LOCAL MEMBERS OBJECTION

APPLICATION No. **16/01739/MJR** APPLICATION DATE: 29/07/2016

LOCATION: 46-48 PARK PLACE, CATHAYS PARK, CARDIFF, CF10 3BB

PROPOSAL: PROPOSED REDEVELOPMENT OF NO.'S 46 TO 48 PARK PLACE FOR THE CONSTRUCTION OF CARDIFF UNIVERSITY'S CENTRE FOR STUDENT LIFE

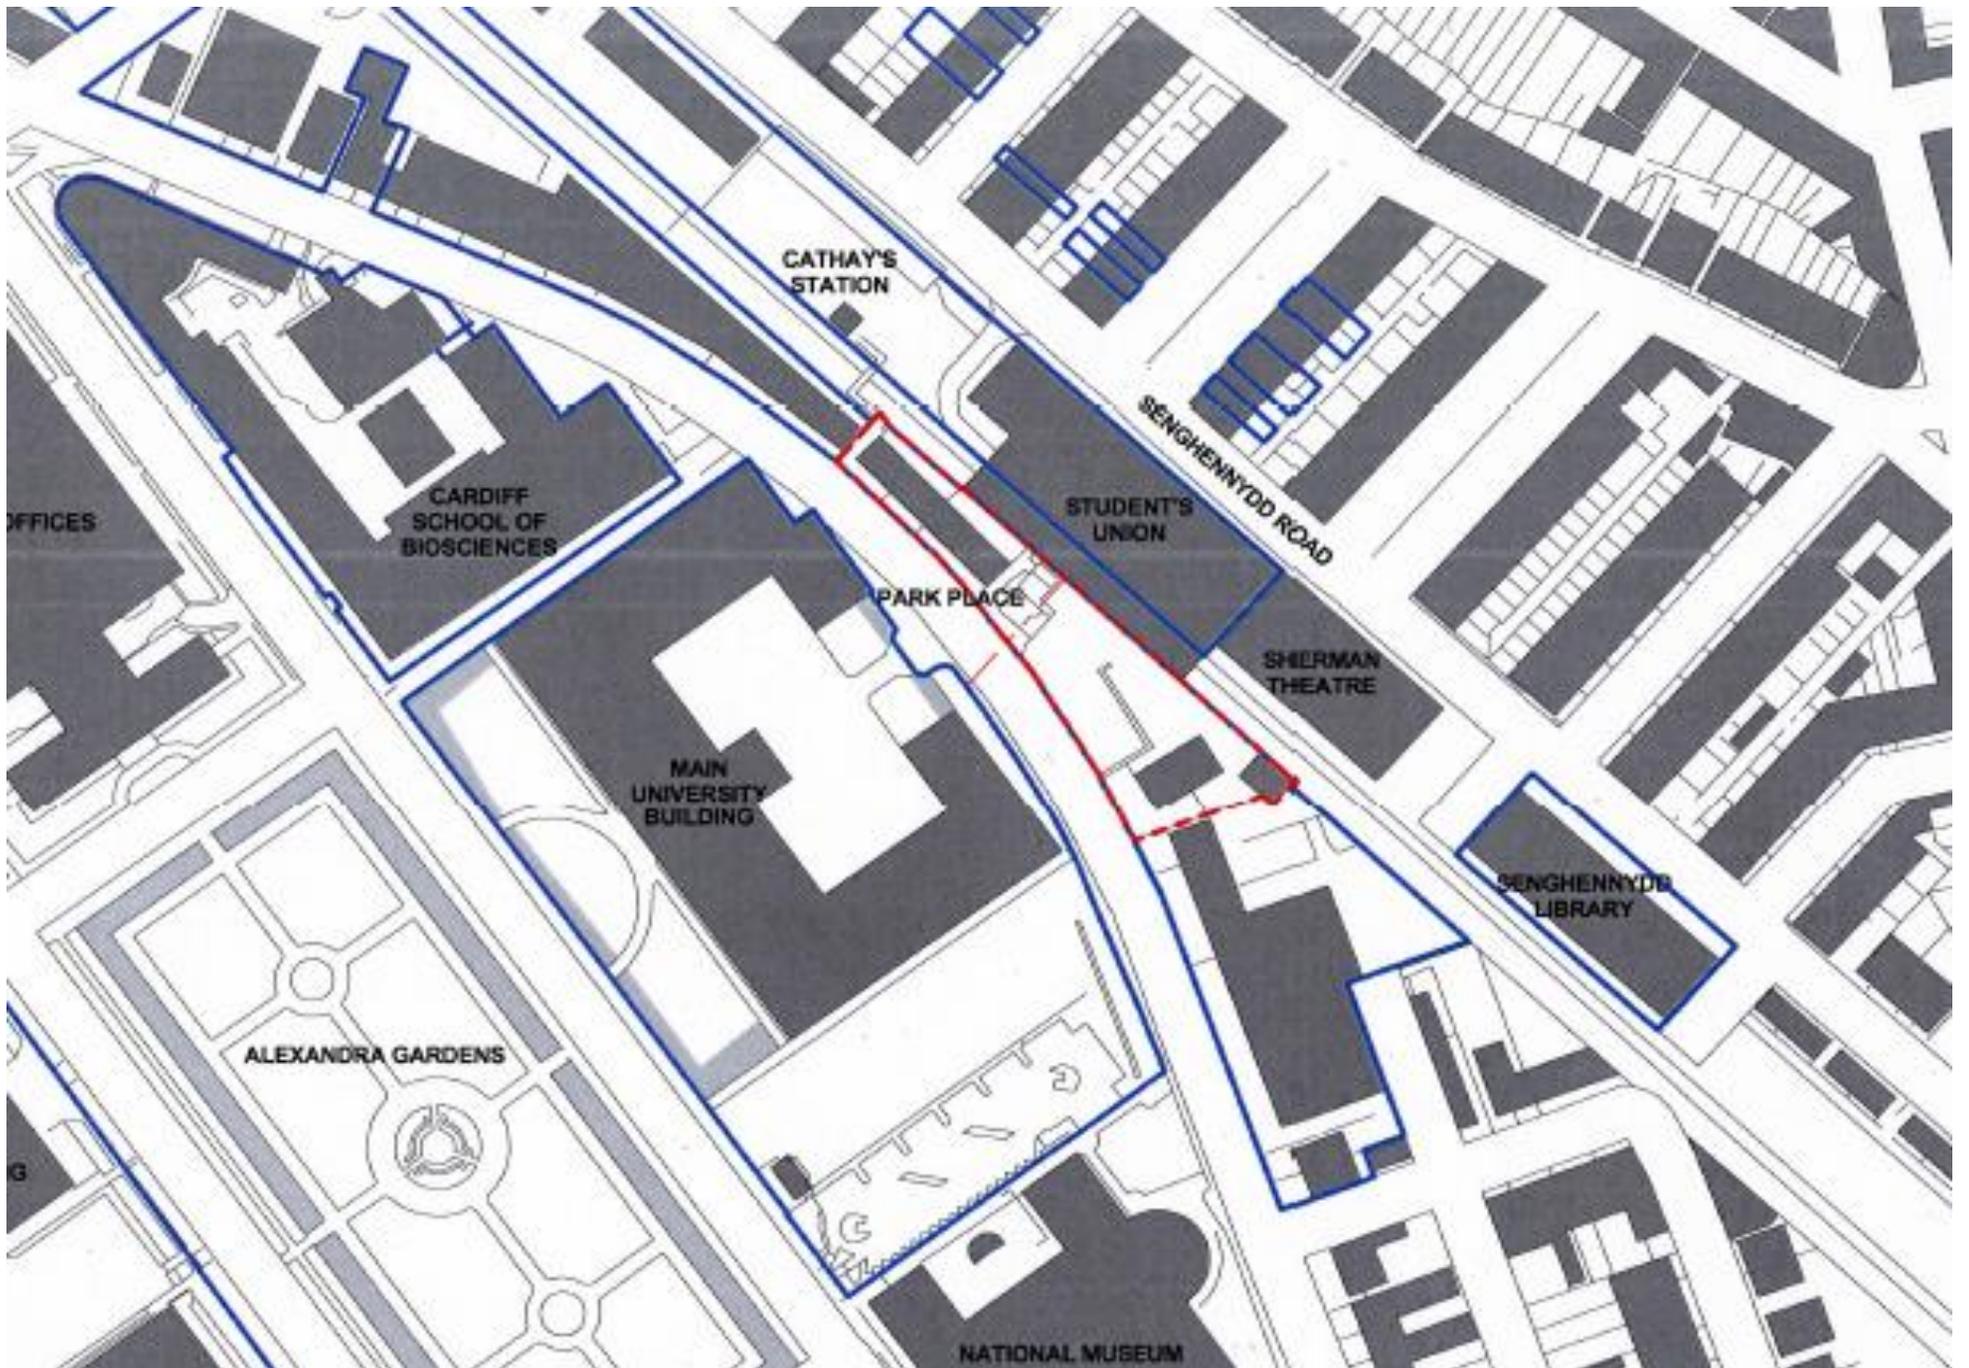
9.2 To implement a scheme of Highway improvement, hard and soft landscaping and such other Public Realm enhancement works as shall be agreed by Members of the Council's Planning Committee to the area indicated on plan Reference 'A' .
